Re: Abengoa Mojave Solar Project (09-AFC-5): Replacement Written Response to Visual Resources Data Request Set 1B, Item 74 and Information Requested by Tom Packard

Visual Resources

Verbal Requests from Tom Packard

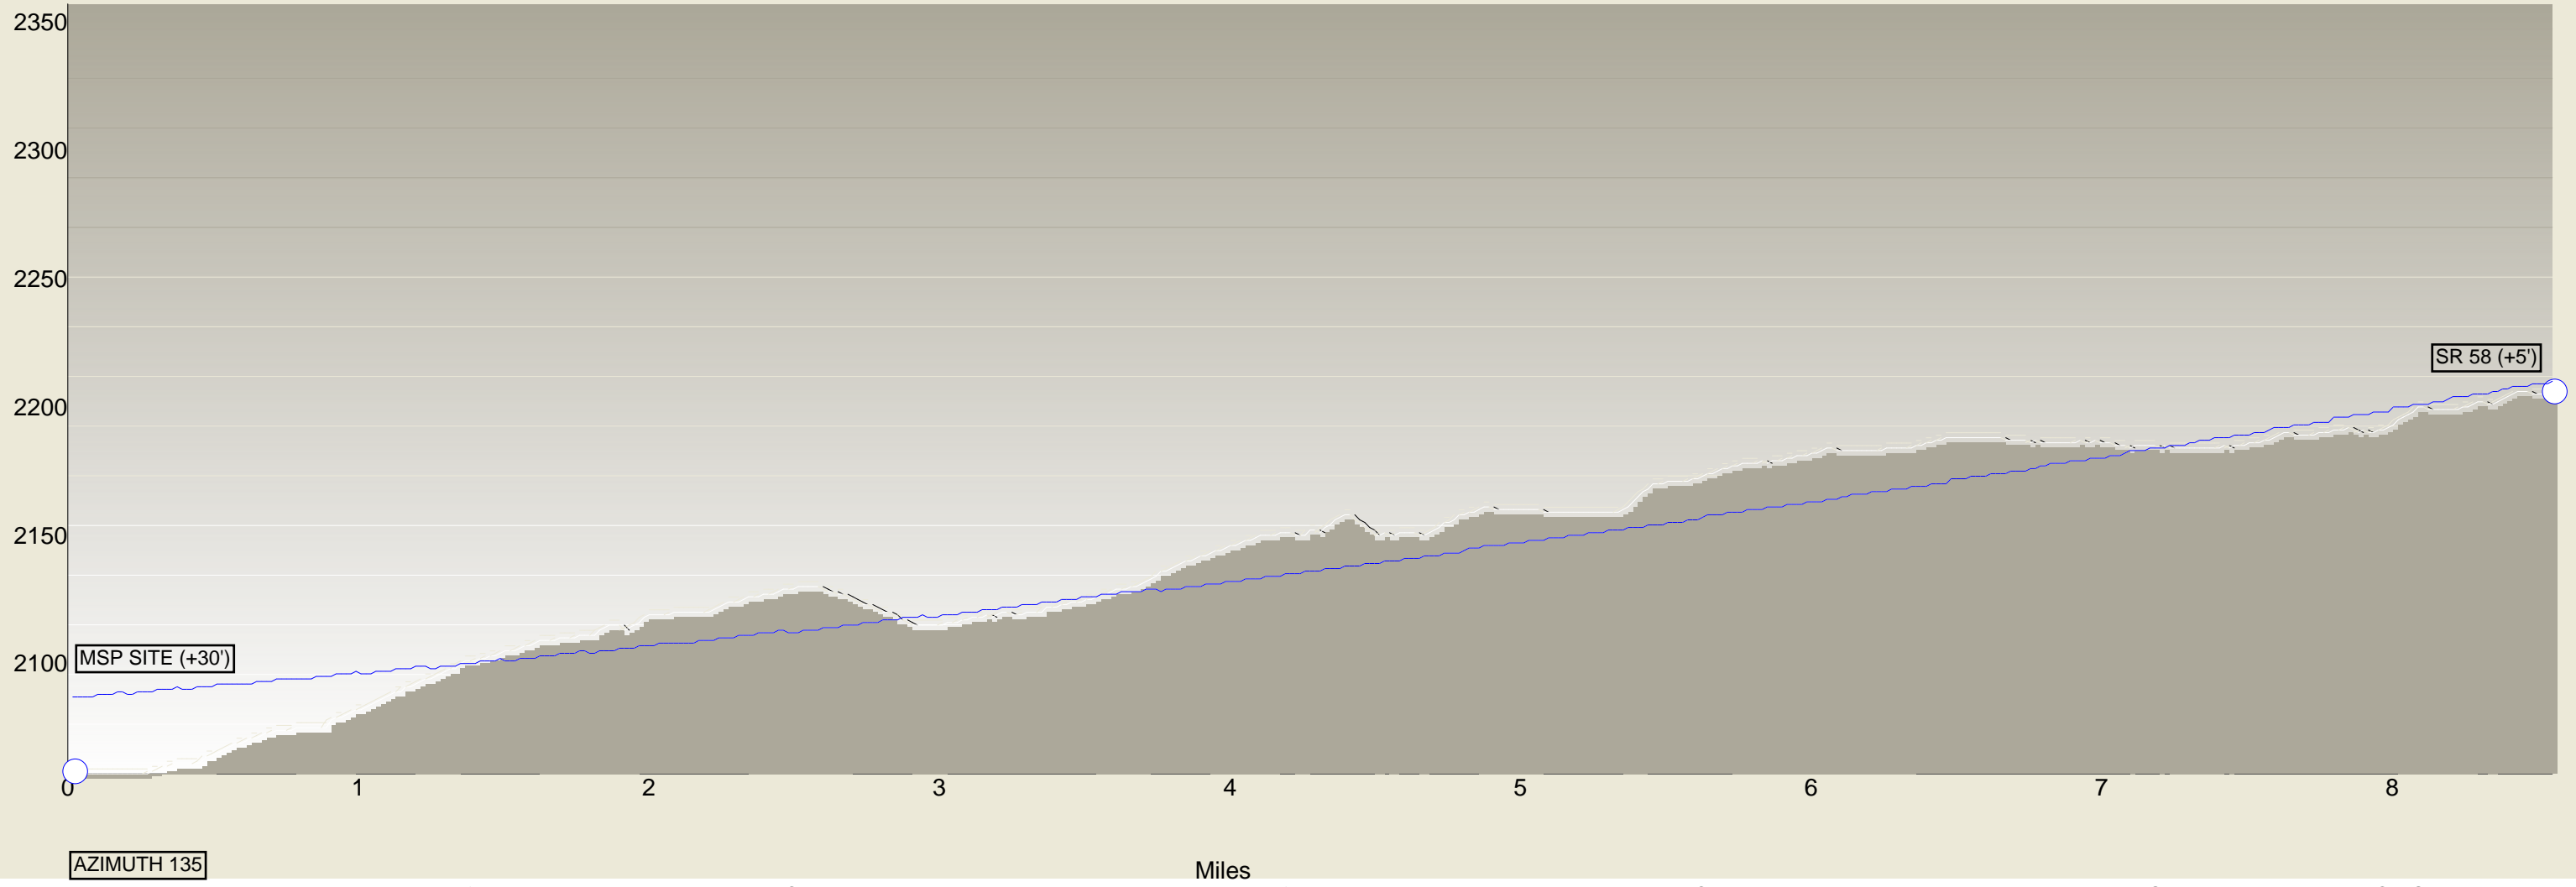
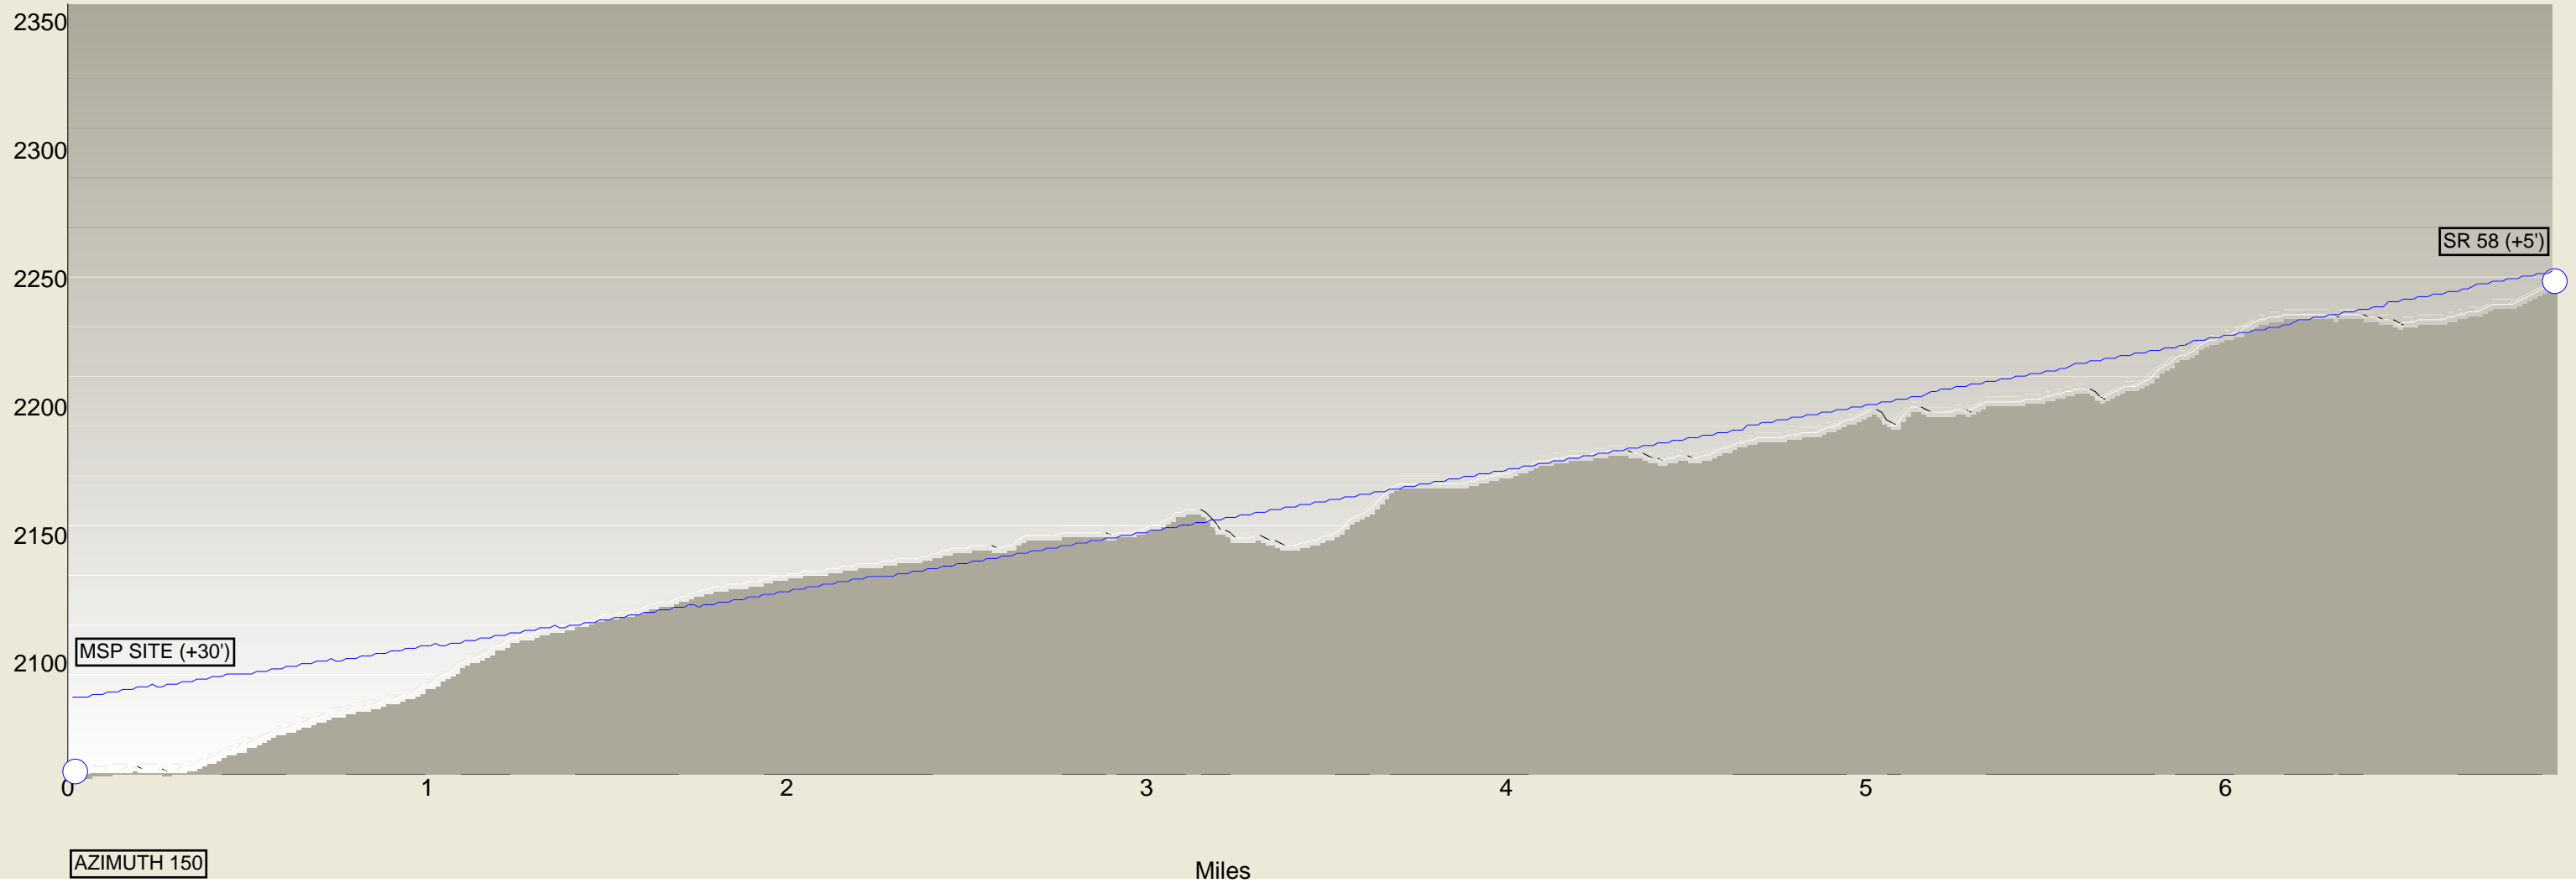
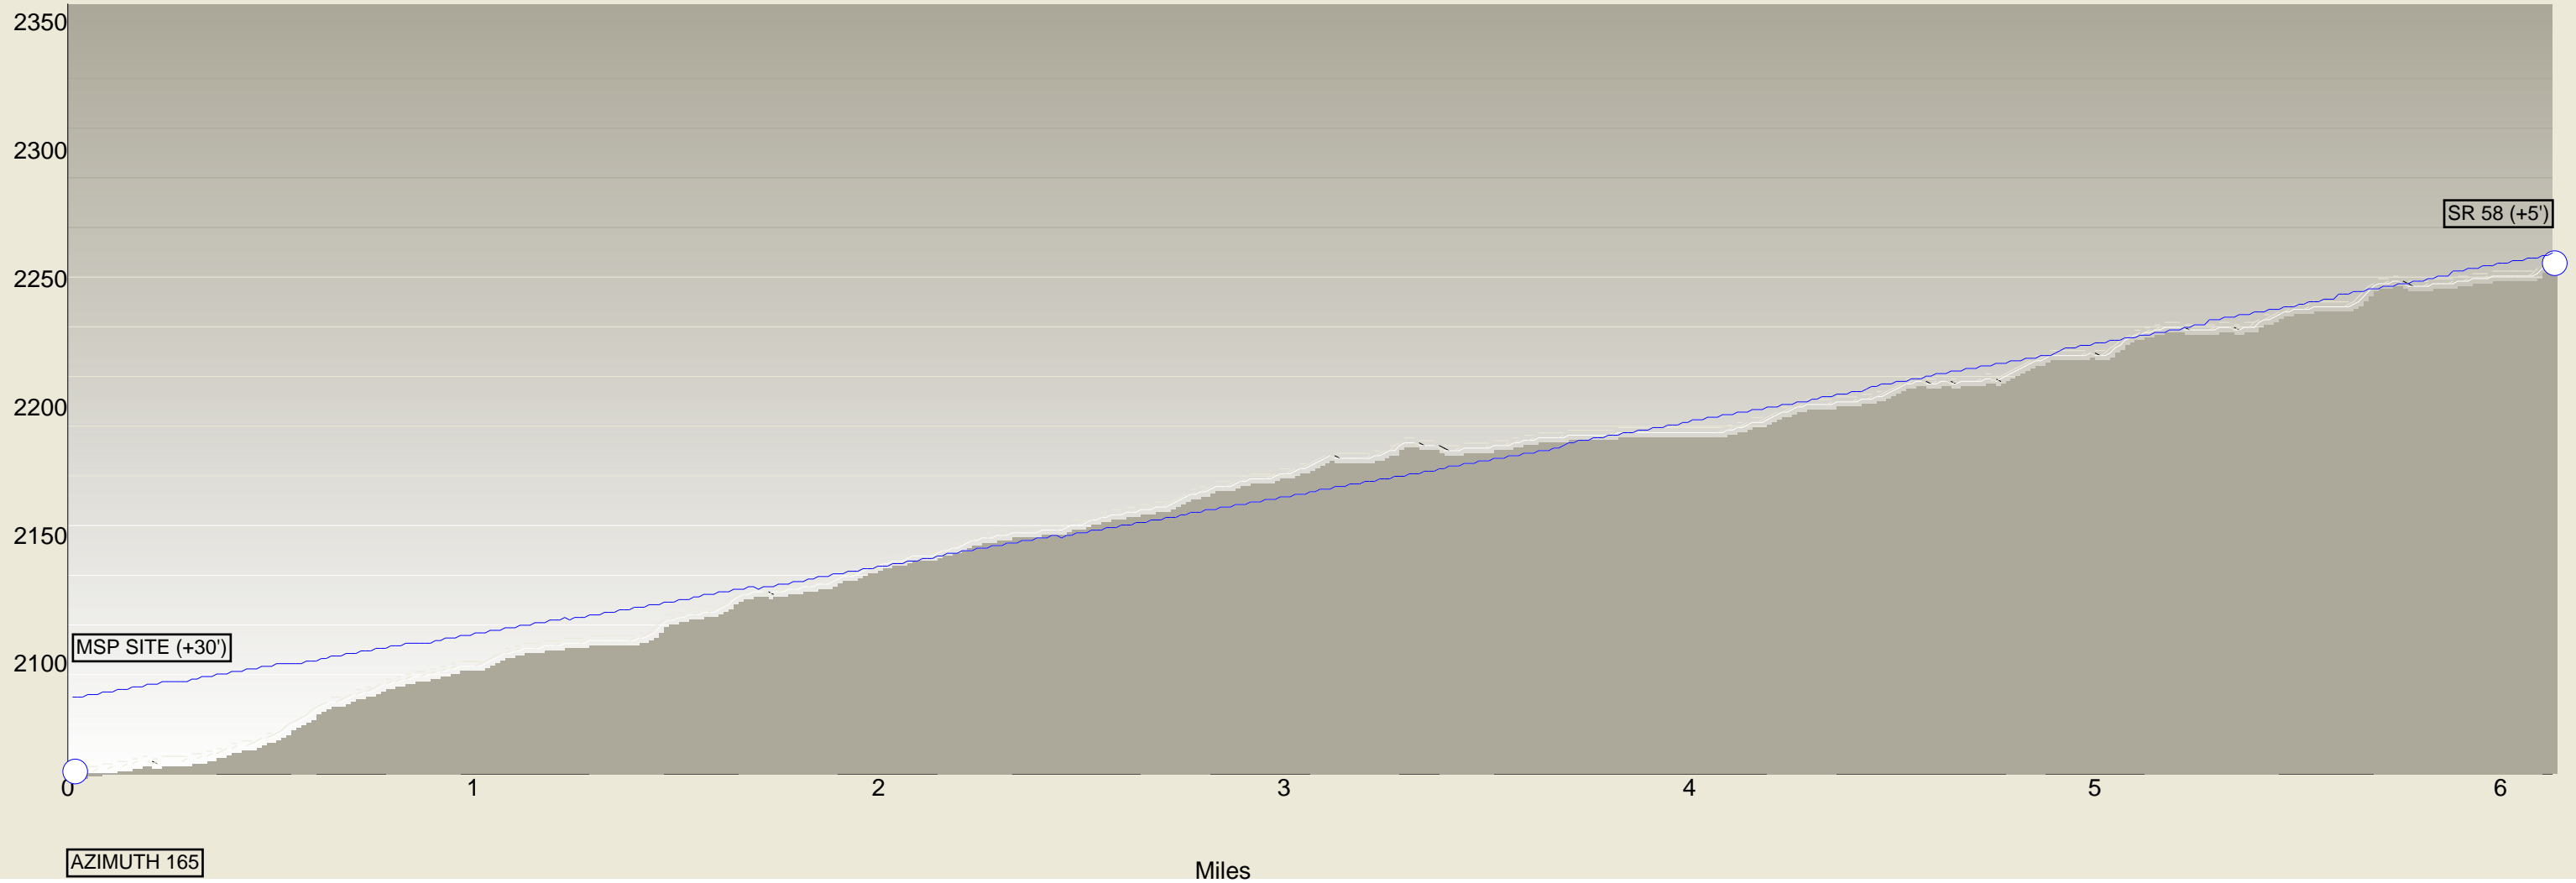
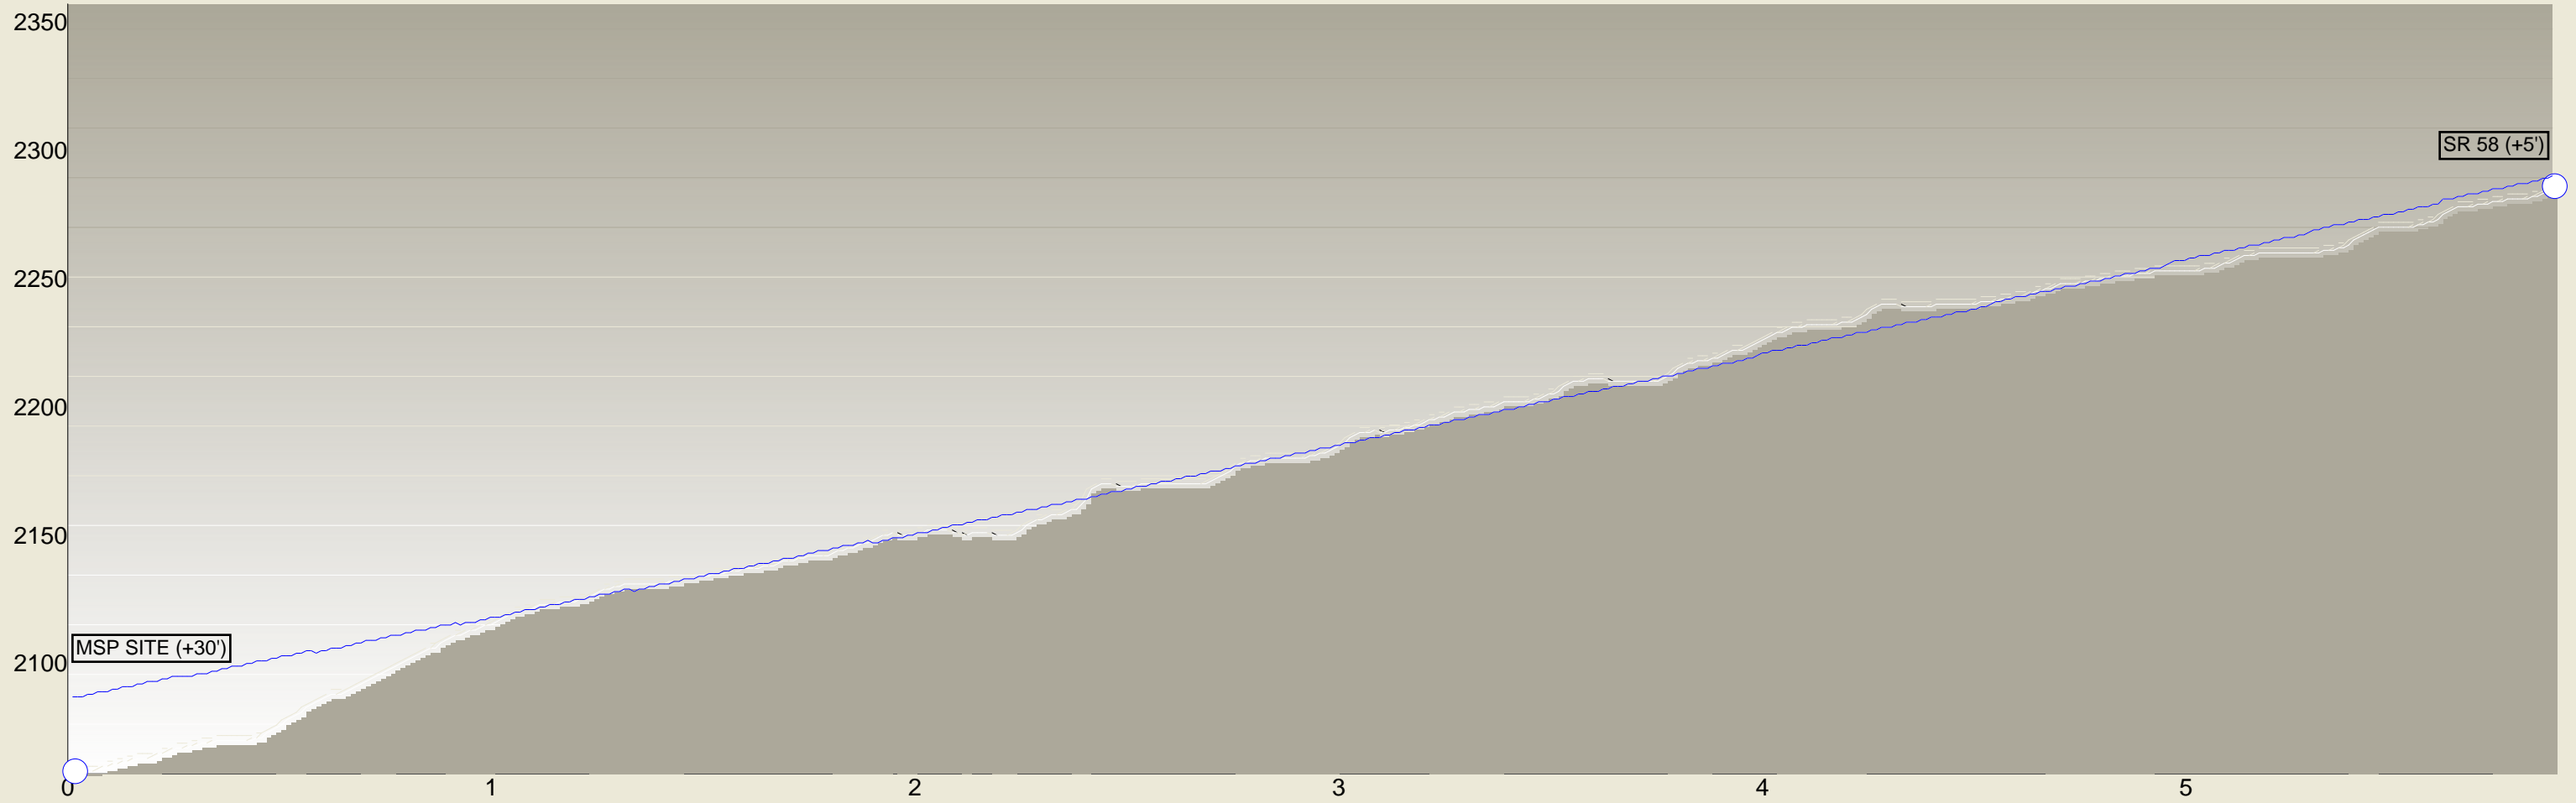
1. Did the visual analysis provided assume a height of finish grade for the analysis? (i.e. did the analysis assume an average height of the equipment?)
2. Did the analysis use USGS mapping?
3. Are there cross-sections available from points along HWY 58 that show the topography obscuring the facility?

1. The analysis used an equipment height of 30 feet above the elevations set for the power islands. This was based upon the mid-point of the tallest structures in the power island area. Then, topography software which is based upon the USGS maps was used to take a cross-section profile at 15 degree azimuth increments around the project site and out to a 15-mile radius.

2. Yes, the software employed is based upon USGS mapping.
3. The following pages contain a base map and cross sections at 15 degree intervals between Highway 58 and the project site. Lines of sight are shown on the cross sections to clarify where topographic visual barriers exist between the highway and the site. The lines-of-sight were set at 30 feet above power island grade at the plant site, as noted previously in response 1, and at 5 feet above road surface on Highway 58 to account for the height of the viewer. Note that the lines-of-sight shown are not straight, but curved to take into account the curvature of the earth over this extended sight distance.
